Service Bulletin

4 - STROKE
TL/SV/DL BULLETIN NO. 34
DATE: 1/23/2006

SAFETY RECALL CAMPAIGN
2003 ~ 2006 SV650/S E-33 AND SV1000/S E-33
CALIFORNIA MODELS ONLY
FUEL TANK REPLACEMENT

SUBJECT: RECALL CAMPAIGN - FUEL TANK REPLACEMENT

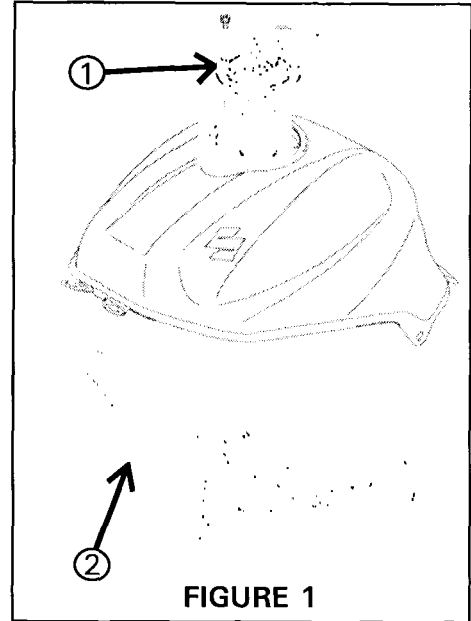
5. Remove the fuel cap assembly ① and the tank heat shield ② and install onto the new fuel tank. (See Figure 1)
6. Using a new o-ring install fuel pump assembly into the new fuel tank.
SV650/S (Refer to SV650/S Service Manual, Pages 5-13)
SV1000/S (Refer to SV1000/S Service Manual, Pages 4-71)
7. Re-install fuel tank and seat. Installation is the reverse order of removal. Replace the fuel.
8. Run the unit and verify there are no fuel leaks and the fuel gauge is working properly.
9. Place an identification punch mark on the frame at the end of the Vehicle Identification Number per Figure 2 to confirm that the recall service has been completed. The VIN is located on the right side of the steering tube.
